SERVICE BULLETIN

No. 664

Piper Aircraft Corporation

Subject: Elevator Torque Tube Attachment Inspection

FIGURE 1

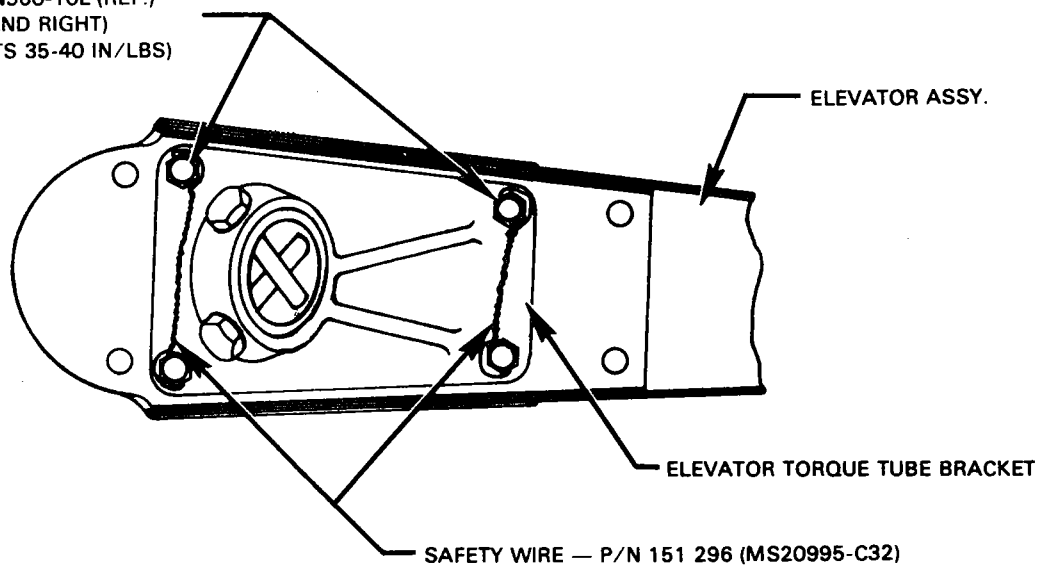
On the above-listed aircraft, a possibility exists of the elevator torque tube attachment to the elevator butt ribs having anchor nuts which do not meet the self-locking requirement. Should the bolts back out of the anchor nuts, impairment of elevator operation or loss of elevator control could result.

1. Remove tail fairing to gain access to the elevator torque tube assembly (see attached sketch).
2. Remove one of the bolts that attach the torque tube to the elevator.
3. Reinstall the bolt using just the fingers. If using just the fingers to tighten, the head of the bolt contacts the forging, loss of the self-locking feature of the anchor nut is indicated.
4. Repeat steps 2 and 3 above on each of the eight (8) affected bolts.

5. If all eight (8) anchor nuts prove to be self-locking, torque bolts to 35-40 inch-pounds, replace tail fairing, and make appropriate logbook entry of compliance with this service release.
6. If one (1) or more of the anchor nuts are not self-locking, then all eight (8) of the affected bolts must be replaced as follows:
 - a. Refer to attached Sketch, Figure 1.
 - b. Replace the eight (8) bolts with drilled head AN3H-5A bolts (Piper Part Number 401 267). Use existing AN960-10L washers.
 - c. Torque bolts to 35-40 inch-pounds.
 - d. Safety wire the forward two (2) bolts and the aft two (2) bolts together with MS20995-C32 Safety Wire (Piper Part Number 151 296).
 - e. Reinstall tail fairing and make appropriate logbook entry of compliance with this Service Release.

1. Eight (8) each AN3H-5A Bolts, Piper Part Number 401 267.
2. As necessary, MS20995-C32 Safety Wire (Piper Part Number 151 296).

BOLT — P/N 401 267 (AN3H-5A)
 WASHER — AN960-10L (REF.)
 4 REQ. (LEFT AND RIGHT)
 (TORQUE BOLTS 35-40 IN/LBS)
